ADDENDUM

Addendum Number One (01)
TO PLANS AND SPECIFICATIONS FOR
Alvin ISD Elementary School #23
STANTEC Project Nos.: 214001269

September 8, 2025

JOB No.: 001567-05	SCALE: 1"= 50'	DATE: 10/23/2024	FIELD BOOK: 24-073/GG
DWG. No.: 001567-05-DWG	DRAWN BY: NPR	CHECKED BY: ARP	M&B No.: N/A

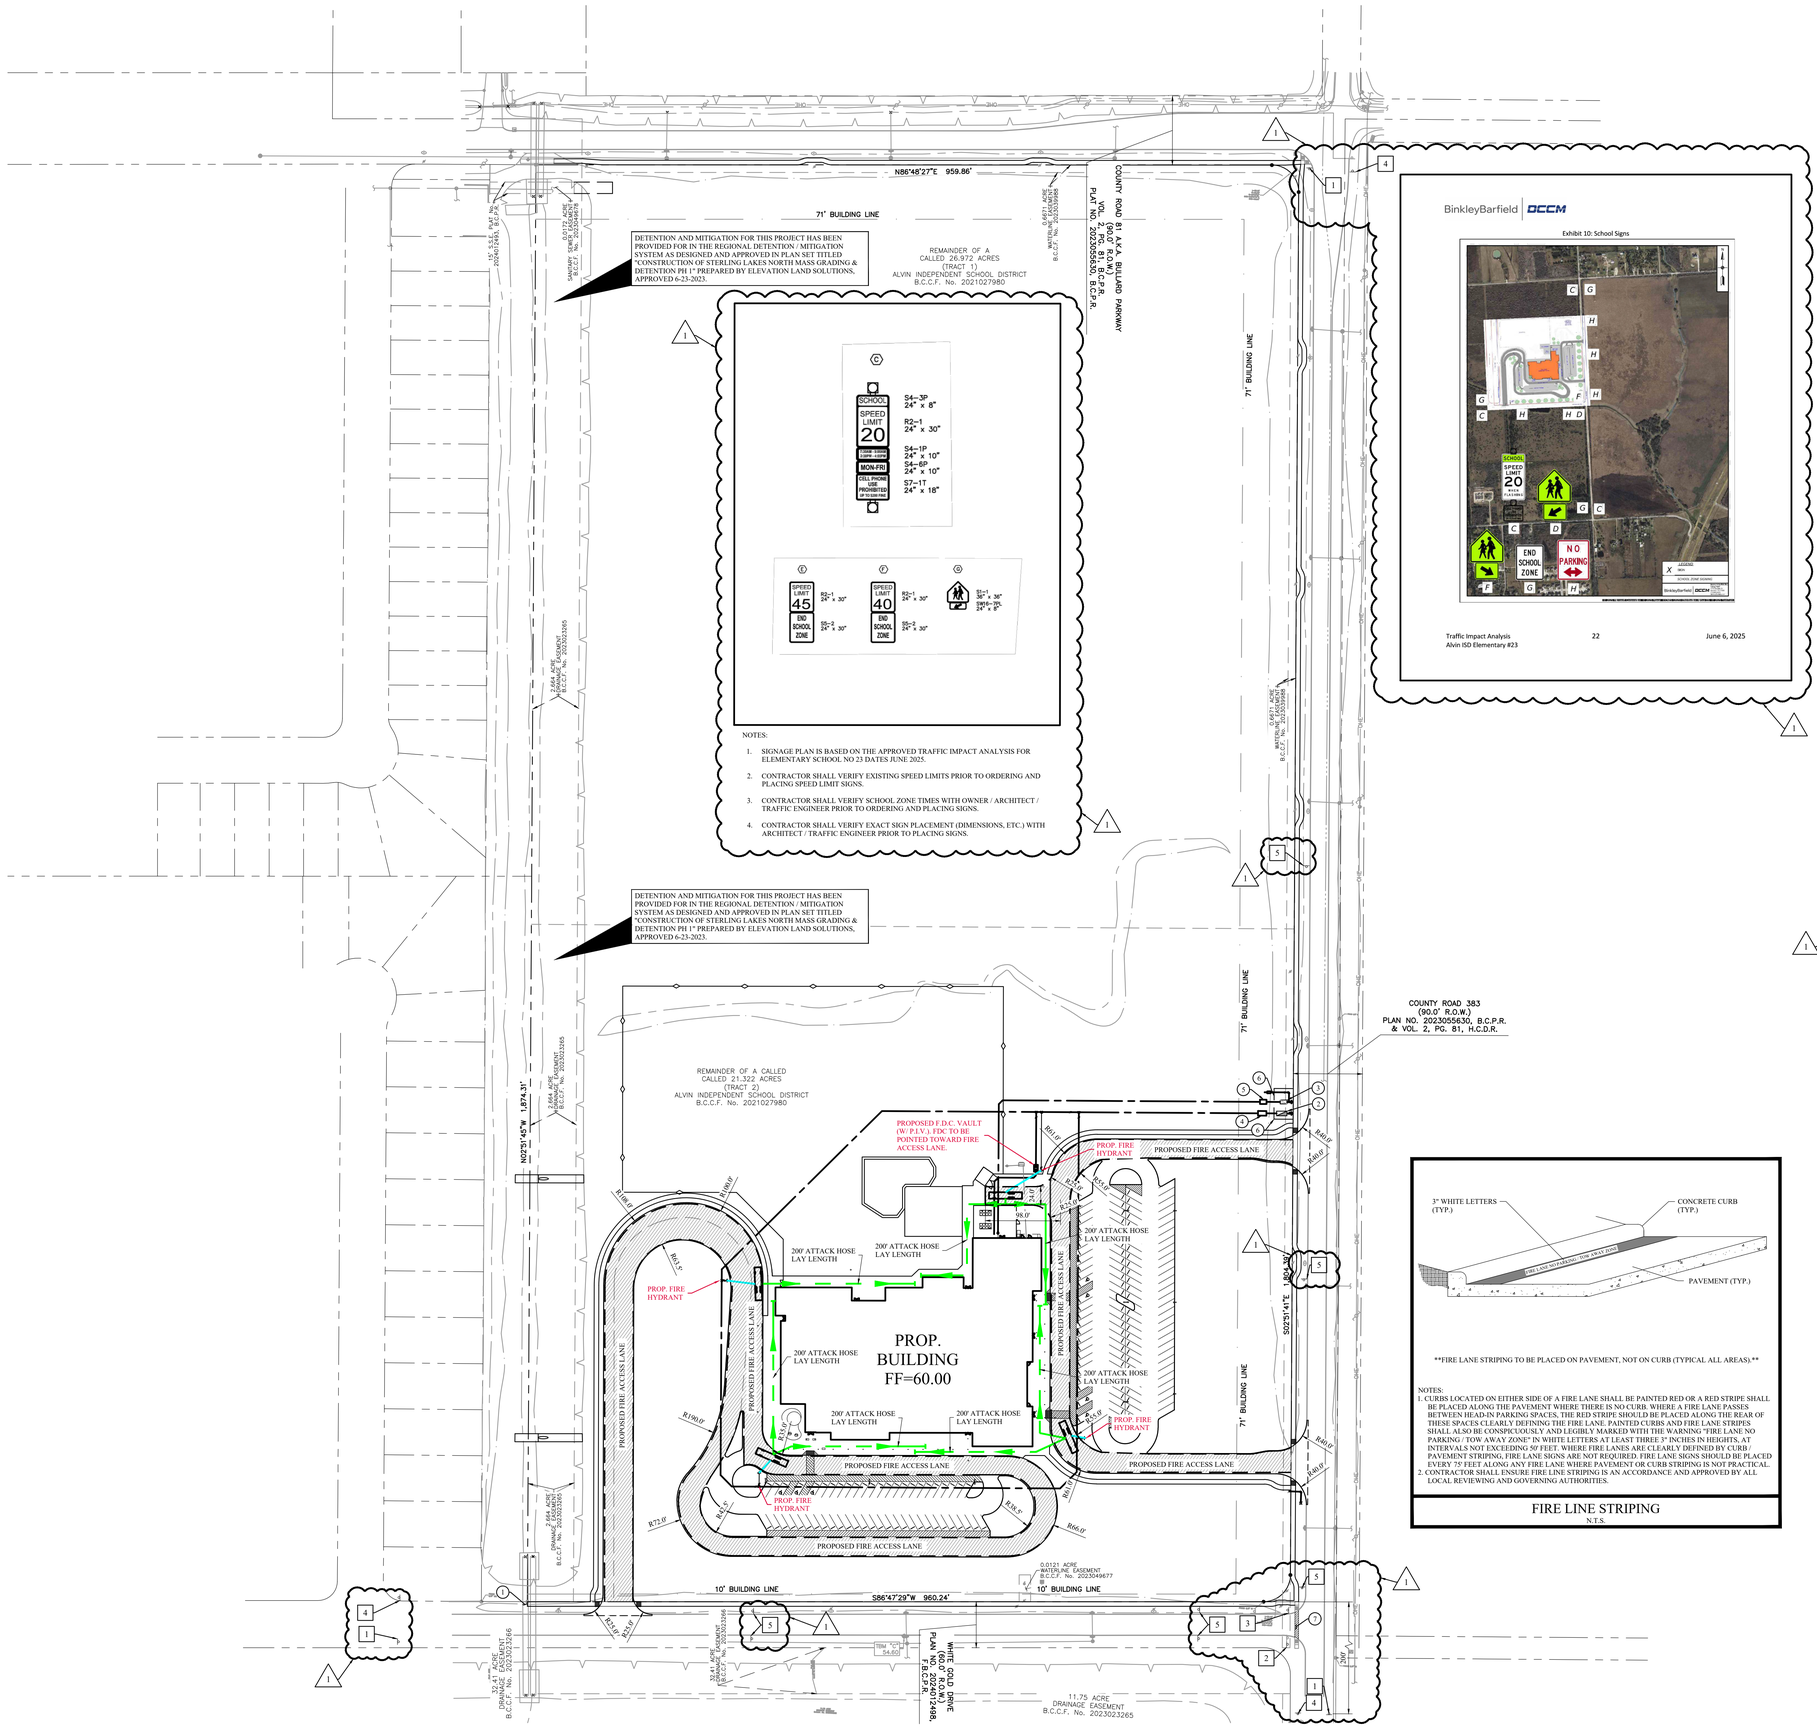
33	Survey	Please provide a topographic survey with clearer elevations. Most existing elevations are able to be read from grading plans, but these are not available for under the building.	The survey is on sheet C002 however it appears a little blurry. We are issueing a clean version of the survey in this addendum.	1
34	Shelving	Shelving is shown in B130, Literacy Lib/Office. Please advise on type and sizing.	this is metal shelving and NIC. It will be turned to dashed lines	1
35	Door HW	The door schedule does not provide detail references or hardware sets, and the hardware specification does not include door #s. Please provide these.	hardware sets are beling updated in Addendum #1	1
36	Tile Patterns	Please provide pattern repeats for tile at corridors and restrooms.	Typical corridor tile patterns are elevations E1 and E3 on sheet A821. Typical toilet room tile patterns are the elevations on sheet A824.	1

C4 A202 **ENLARGED SOUTH EXTERIOR PARTIAL ELEVATION 2**
1/8" = 1'-0"

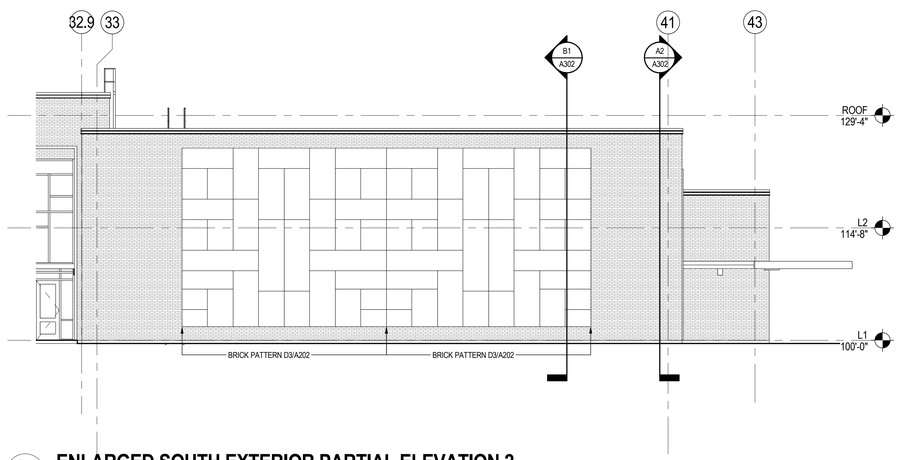
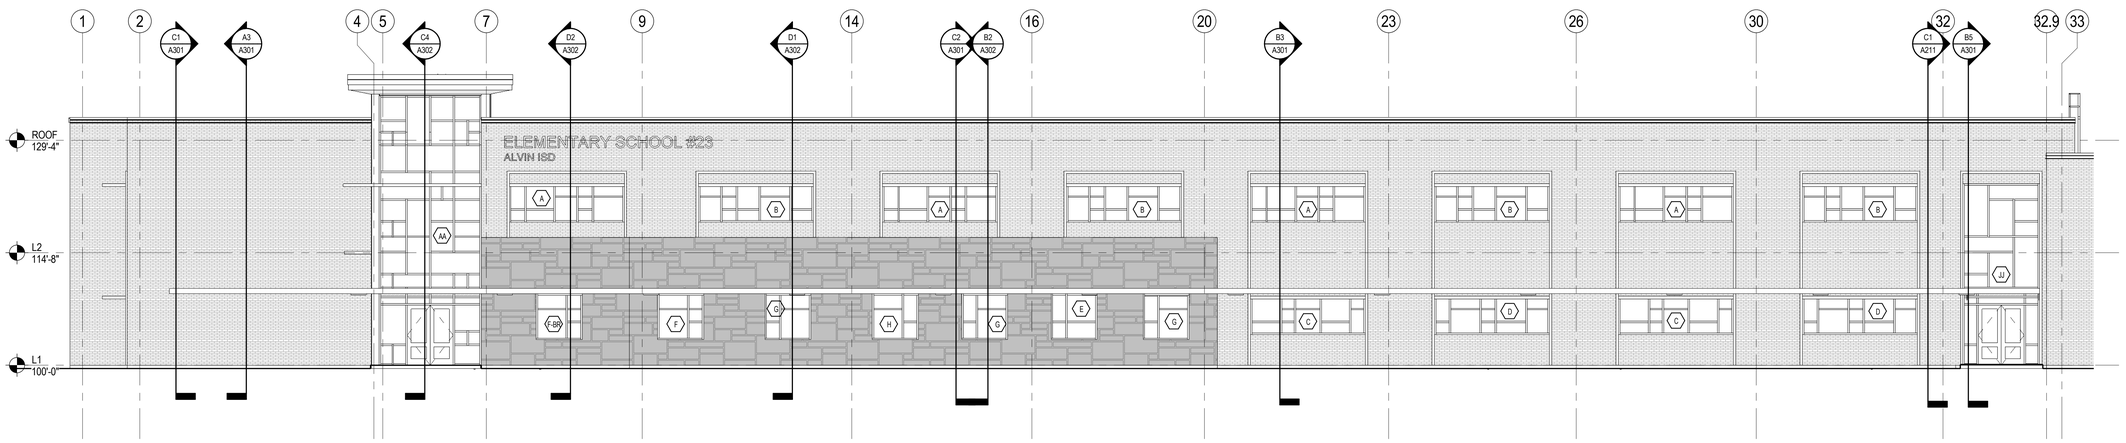
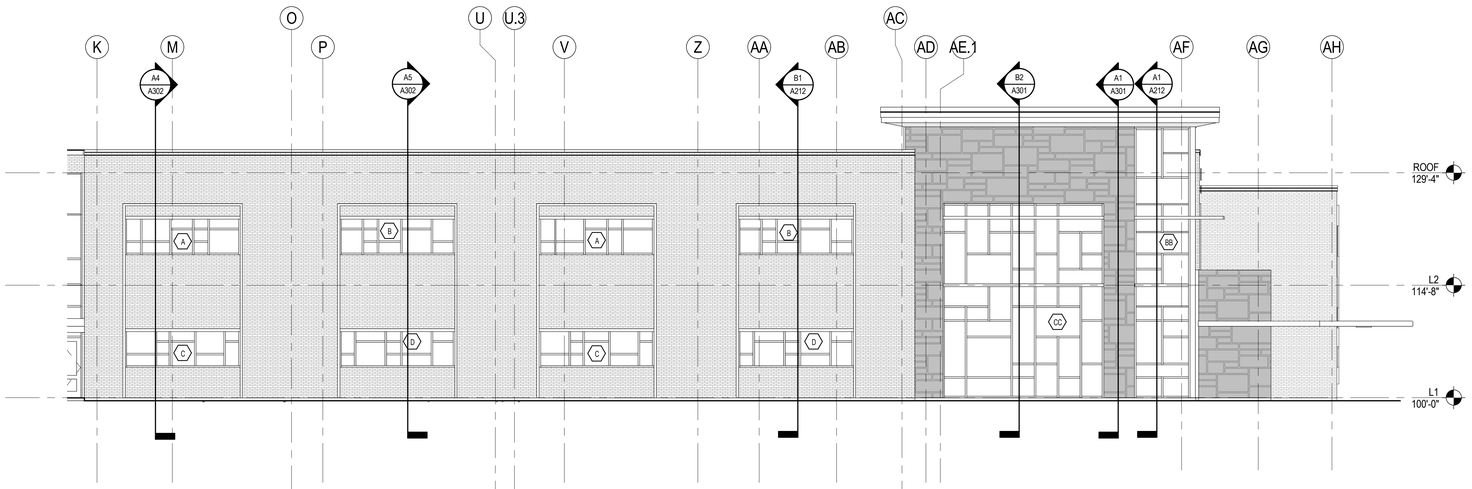
11	A4, C4 / A202	Please identify the exterior finish between gridlines 33 and 41 on detail A4 on A202, and between gridlines U and AC on detail C4 on A202. The finish shown is not in the exterior material schedule and there is no callout shown.	Will be clarified in Addendum #1	1
12	A621, A622	Please clarify ceiling material at overhang of roof at the north end of the overhang between areas A and B	Will be clarified in Addendum #1	1
13	M601	Confirming all Remarks under the respective equipment schedule are applicable to all scheduled equipment or is there a notes column that will show specific notes?	For this sheet, schedule remarks apply to all their respective scheduled equipment.	1

1 PLUMBING SITE PLAN
1" = 20'-0"

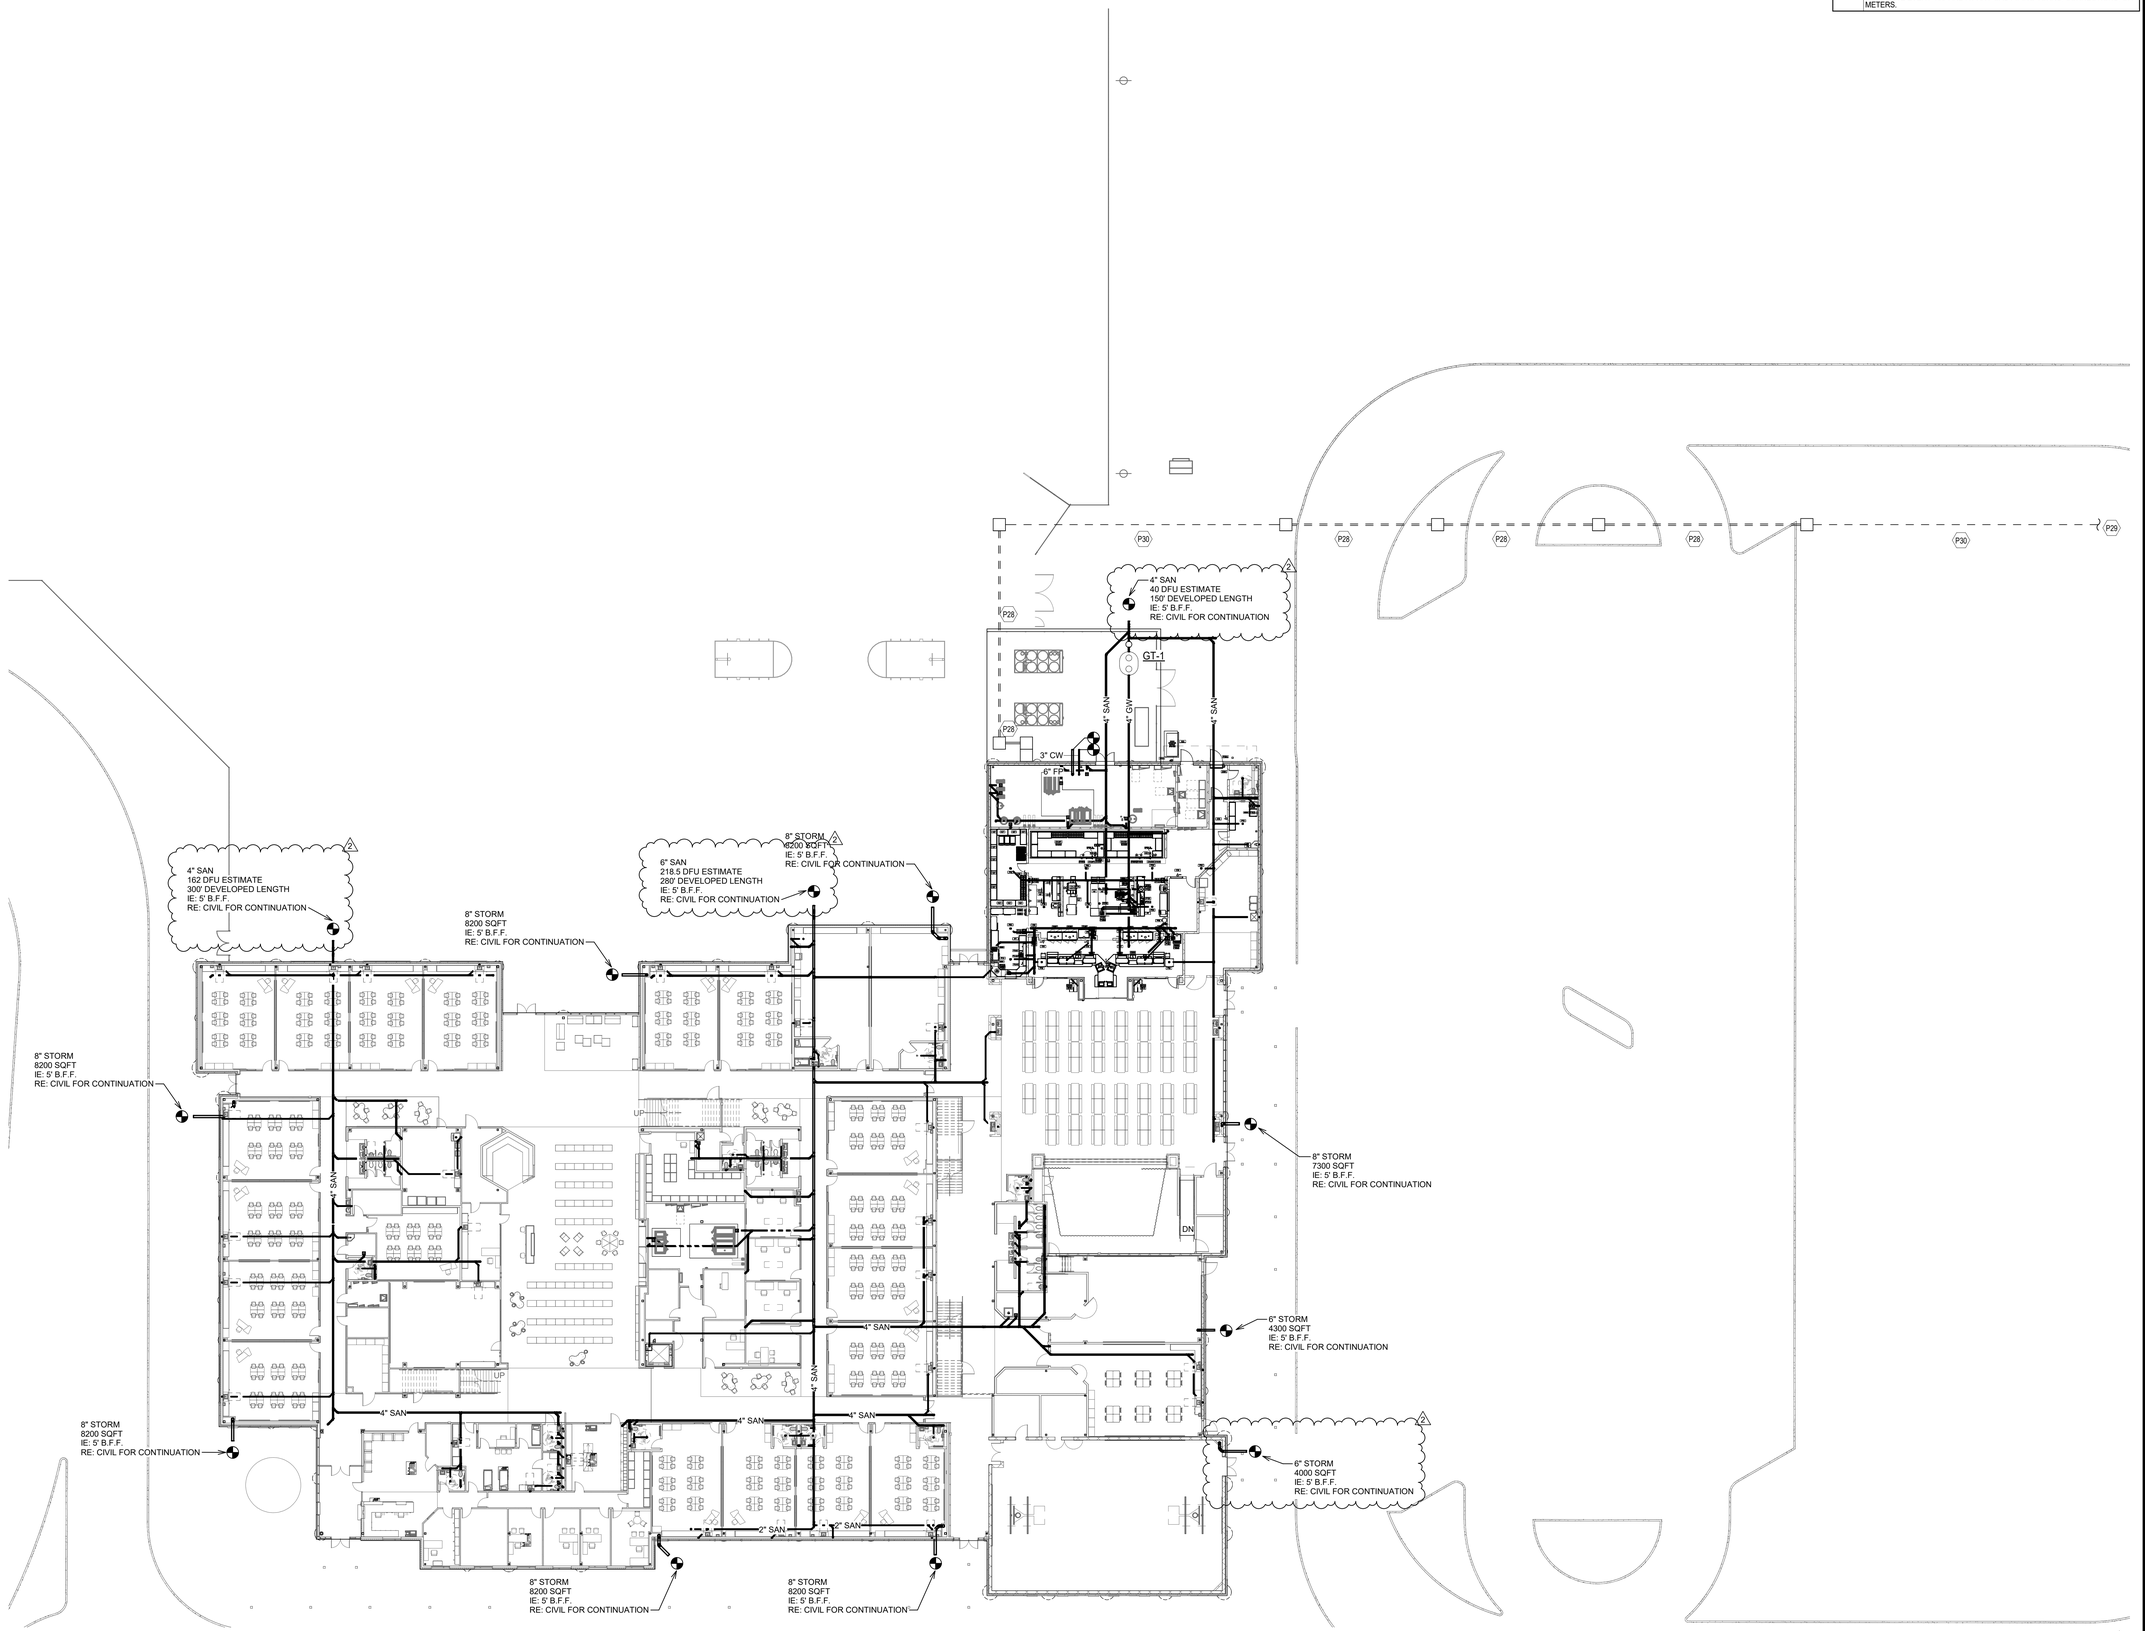
1. Sheet P002 – PLUMBING SITE PLAN
   - Revised storm points of connection.
   - Revised sanitary POC callouts.
2. Sheet P101 – LEVEL 1 - UNDERSLAB PLUMBING PLAN - AREA A
   - Sink locations revised.
3. Sheet P211 – LEVEL 1 - PLUMBING PLAN - AREA A
   - Added Mech room floor sinks.
   - Added hot water balancing valve tags.
4. Sheet P212 – LEVEL 1 - PLUMBING PLAN - AREA B
   - Added hot water balancing valve tags.
5. Sheet P214 – LEVEL 1 - PLUMBING PLAN - AREA D
   - Revised to pick up new sink.
6. Sheet P221 – LEVEL 2 - PLUMBING PLAN - AREA A
   - Added Mech room floor sinks.
7. Sheet P222 – LEVEL 2 - PLUMBING PLAN - AREA B
   - Added Mech room floor sinks.
   - Removed classroom sinks.
8. Sheet P223 – LEVEL 2 - PLUMBING PLAN - AREA C
   - Revised to pick up new sink.
9. Sheet P303 – PLUMBING ENLARGED PLANS
   - Revised sanitary.
10. Sheet P401 – PLUMBING DETAILS
    - Revised detail.
